Subject: **Response to April 5, 2011 FDEP Comments  
Countryside Executive Golf Course**  
2506 Countryside Blvd.  
Clearwater, Florida  
*HSA Project Number 601-5982-00*

**HSA Engineers & Scientists (HSA)**, on behalf of Executive Corporation of Clearwater, Inc., respectfully submits this response to the Florida Department of Environmental Protection (FDEP) April 5, 2011, correspondence that provided comments to the June, 2010, *Remedial Action Plan* and Response to the Department's Comments dated January 2011 prepared by HSA for the above-referenced site. For ease of review, the Department's comments are presented below, followed by HSA's responses.

SHEET TITLE  
GROUNDWATER  
ELEVATION  
CONTOUR MAP  
UPPER SHALLOW  
ZONE  
(5/26/11)

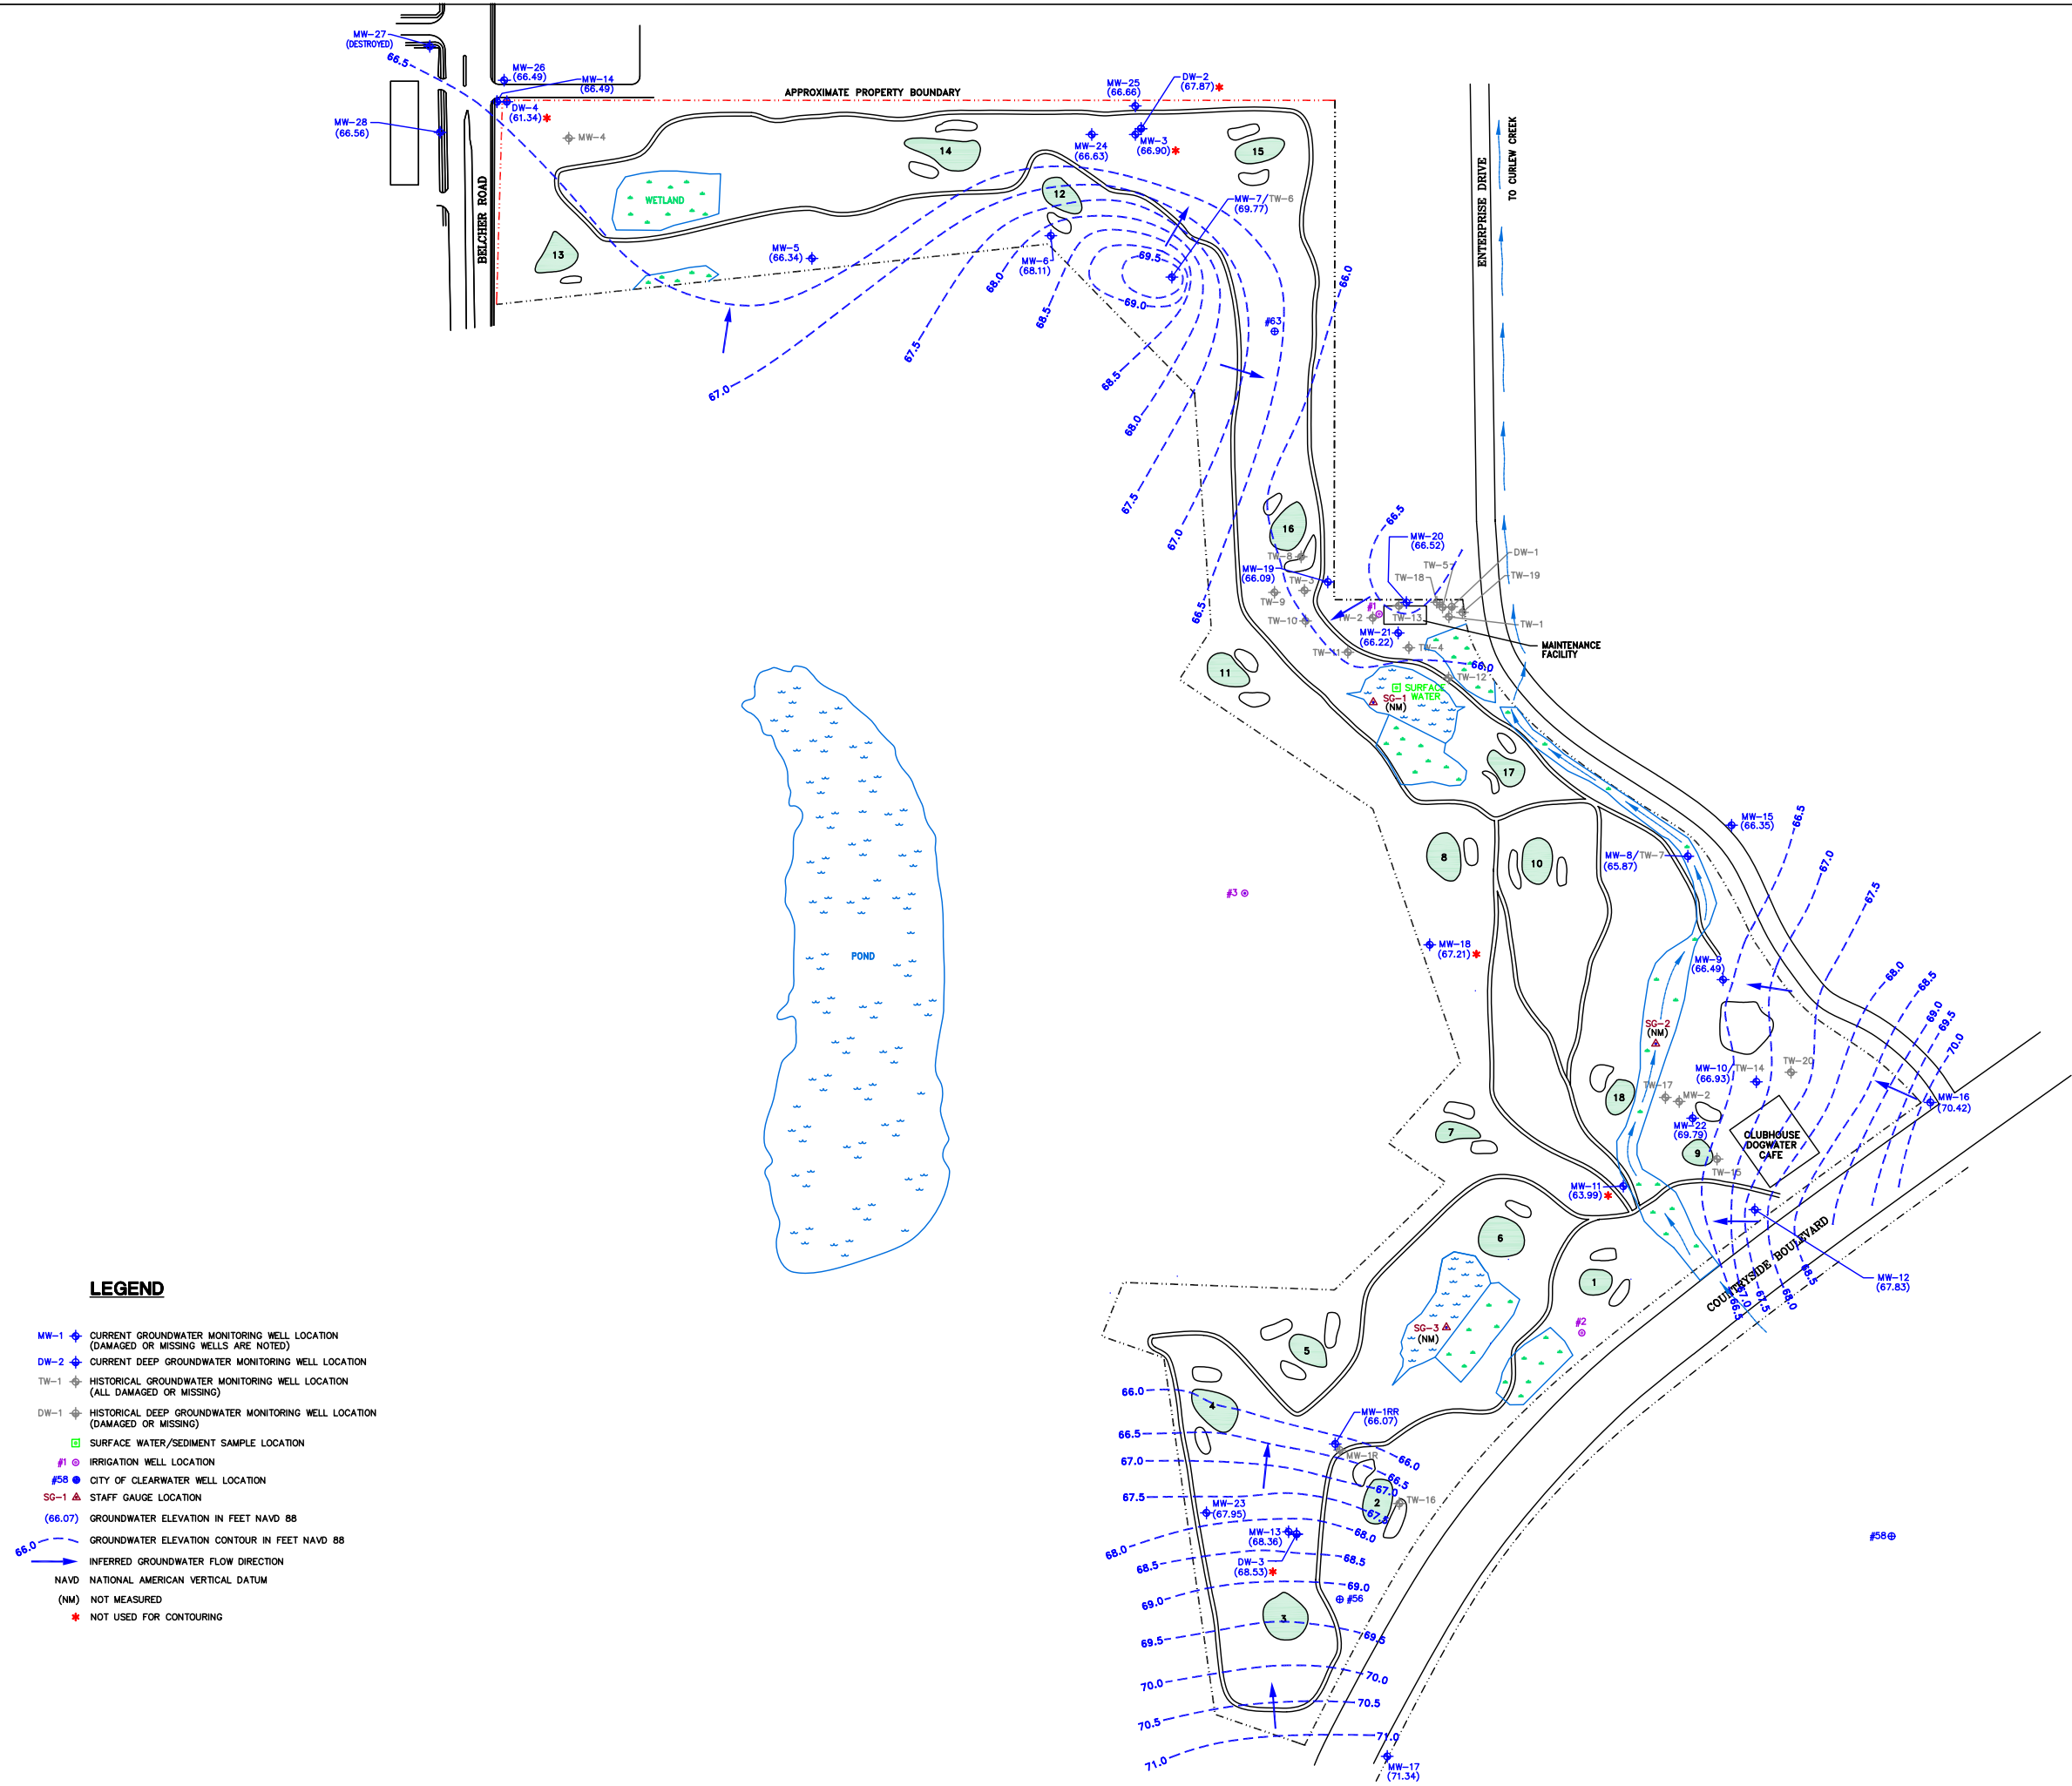
*Comment 1: The response to comment 9 states that Monitoring wells MW-22, MW-23, MW-25, MW-26, DW-2, DW-3 and DW-4 are proposed as point of compliance wells and shall not exceed the applicable default Groundwater Cleanup Target Level (GCTL) of 10 µg/L for arsenic is present in MW-23 at a concentration of 14.7 µg/L. This well should be resampled and, if arsenic concentrations continue to exceed the GCTL of 10 µg/L for arsenic, additional delineation may be necessary.*

Current groundwater elevation data indicate a general decrease in depth to water since the last sampling in December (resulting in a higher groundwater table). Based on the most recent data, groundwater flow is generally towards the north-northwest across the site with some variations within the southern portion of the site due to the presence of ditches and/or ponds. The horizontal hydraulic gradients were measured between monitoring wells MW-23 and MW-16 at in southern part of the site and between monitoring wells MW-10 and MW-16 at the eastern part and estimated at 0.048 feet per foot (ft/ft) and 0.011 ft/ft, respectively. A groundwater elevation contour map for the shallow zone is included as **Figure 1**. The current groundwater flow direction is generally consistent with historical observations.

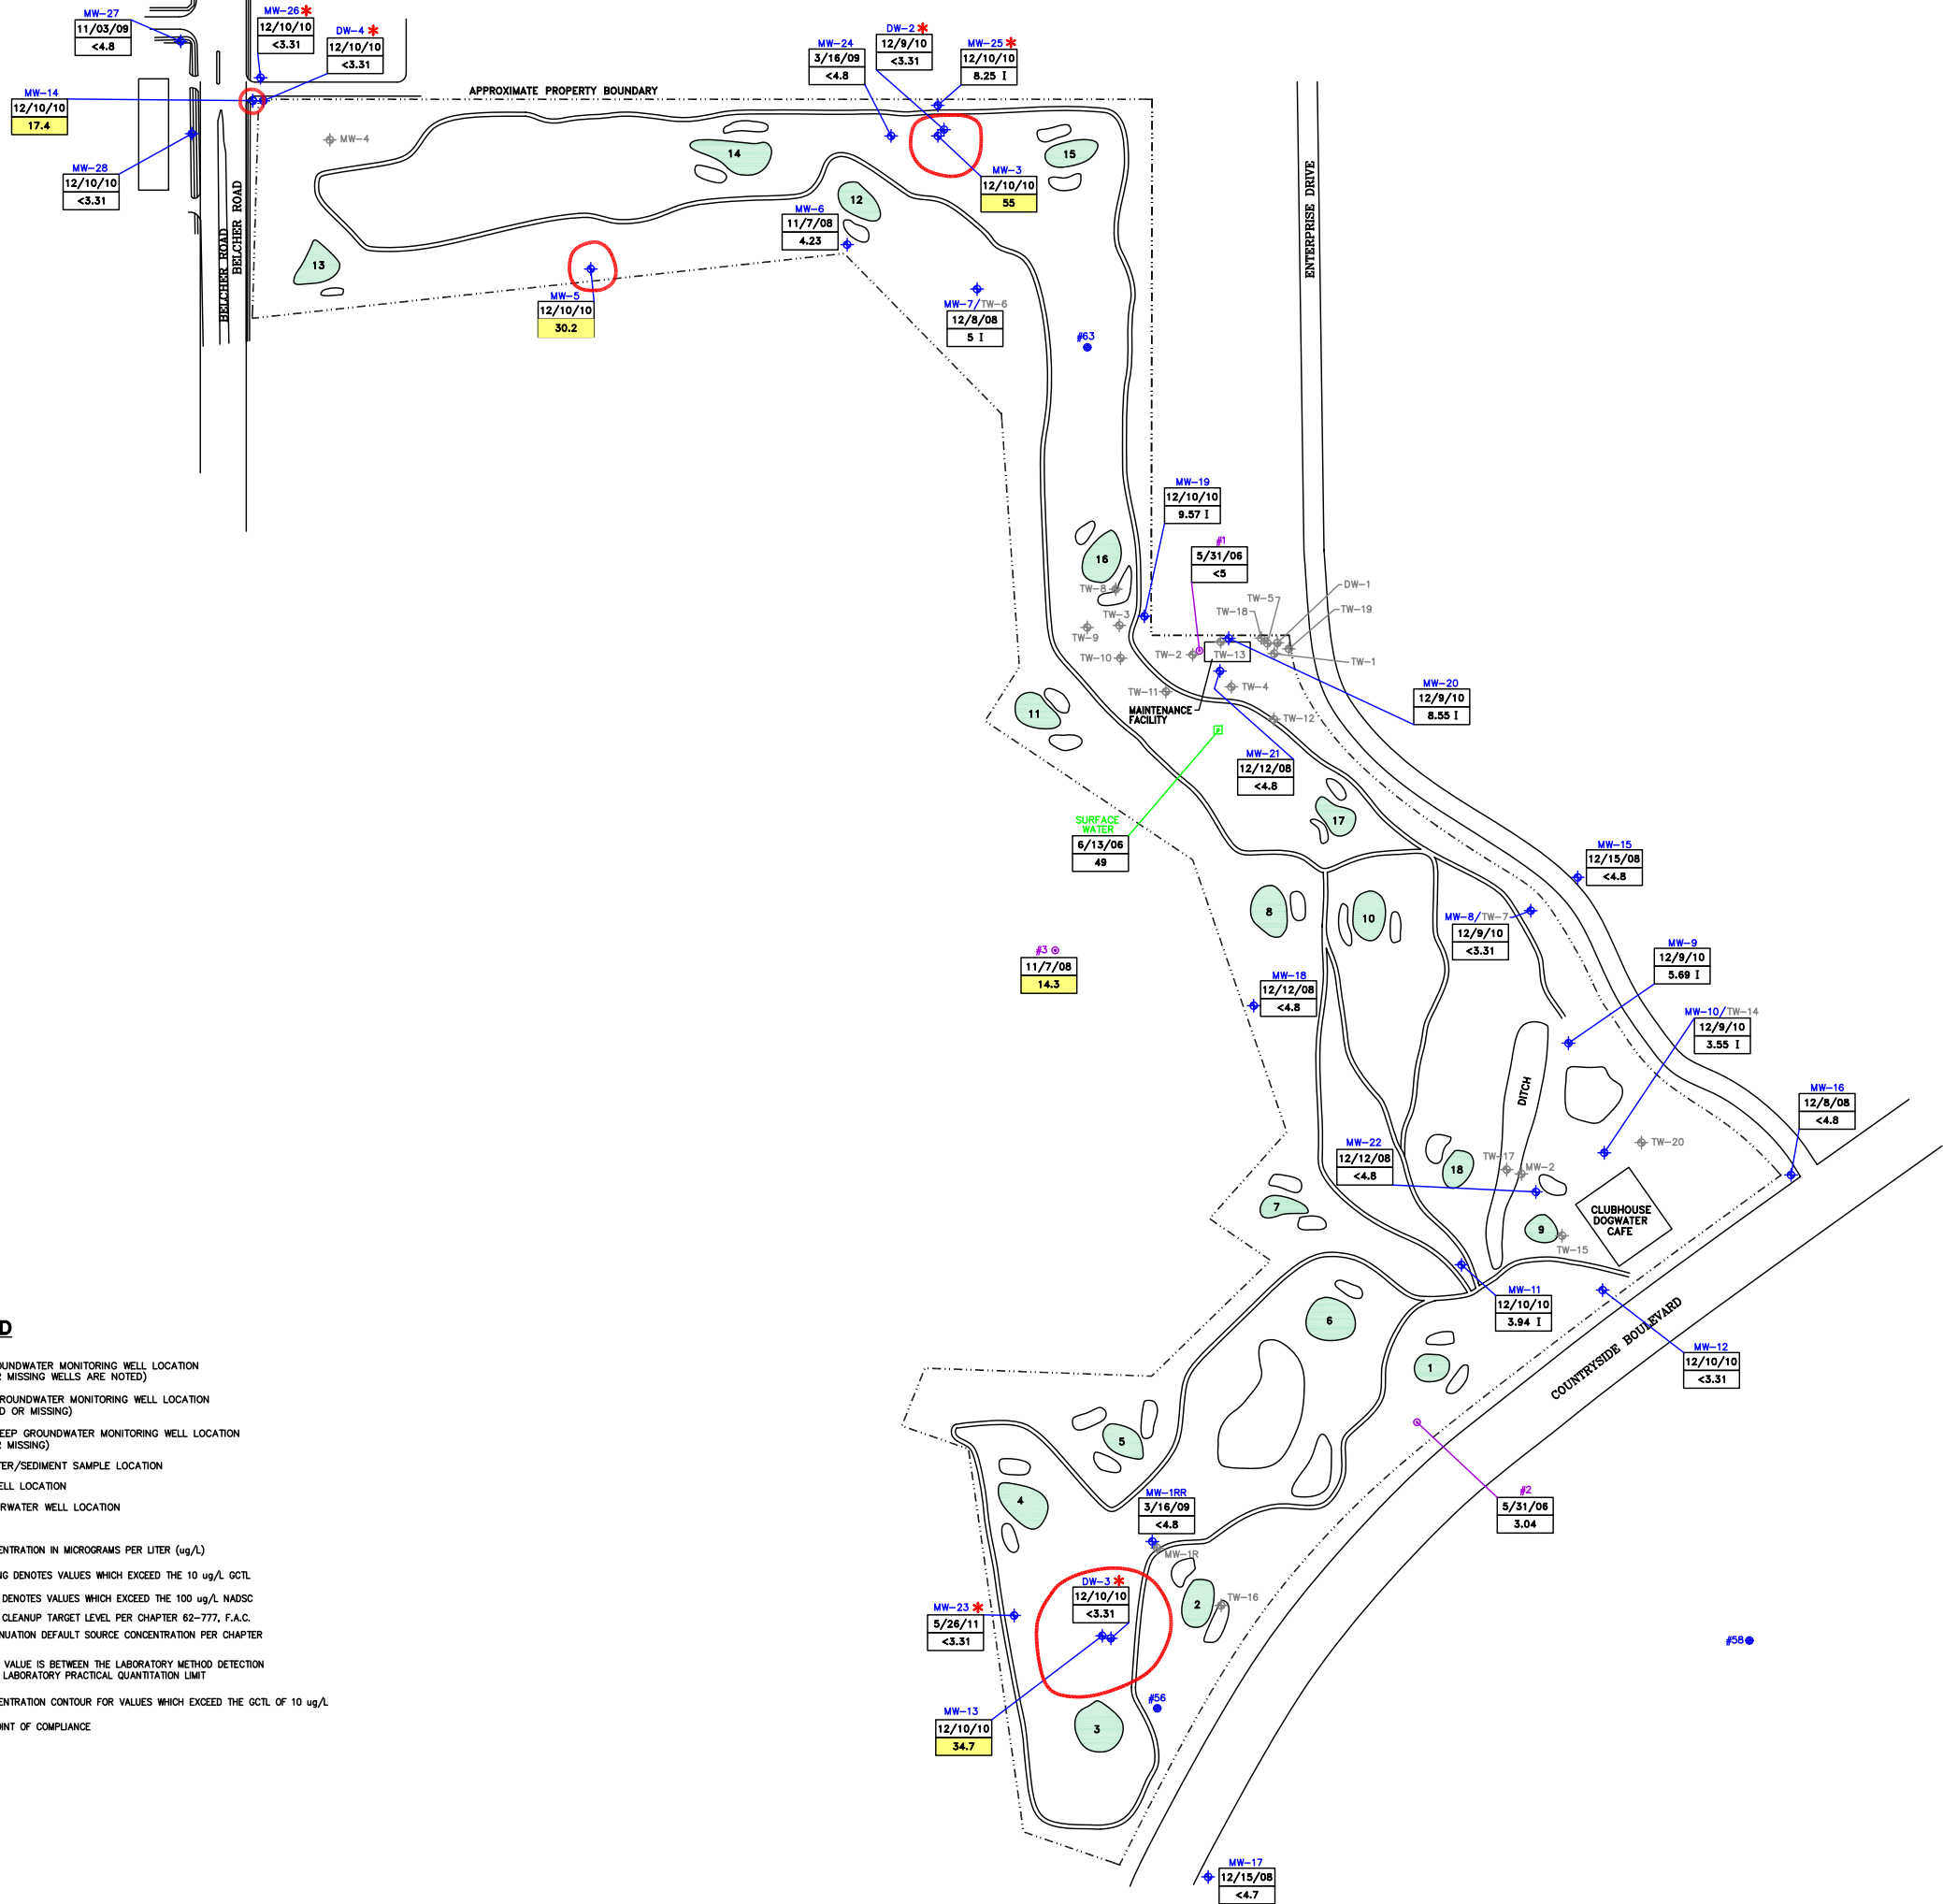
*Comment 3: Monitoring points located beyond the compliance boundary lines must not exceed applicable GCTLs and the point of compliance boundary lines must not extend beyond approved limits due to any changes in arsenic concentrations.*

*Comment 4: Isoconcentration contour lines should be reconstructed for MW-14 and MW-23 to show lines of compliance interpolated proportionately between known monitoring well concentrations. Include all groundwater results as less than the reported Method Detection Limits (<MDLs). Please note that Point of Compliance (POC) boundary lines must be accurately drawn since these compliance lines will be used to determine which properties must be included in the TPOC publication.*

Response: Acknowledged. Monitoring wells MW-23, MW-25, MW-26, DW-2, DW-3, and DW-4 are proposed as the point of compliance wells and shall not exceed the applicable default GCTL of 10 µg/L. As discussed above, the monitoring well MW-23 recently sampled, does not exhibit a concentration of arsenic at detectable levels. Temporary Point of Compliance (TPOC) wells and the compliance boundary lines are included in the attached **Figure 2**.

Response: Acknowledged. The revised groundwater analytical map includes the isoconcentration contour lines reconstructed accordingly and included as a **Figure 2**. Although, isoconcentration contour lines were interpolated proportionally between known monitoring wells MW-13 and MW-17, based on the groundwater flow direction, the contaminant plume in vicinity of monitoring well MW-13 less likely to be present beyond the boundary to the south.
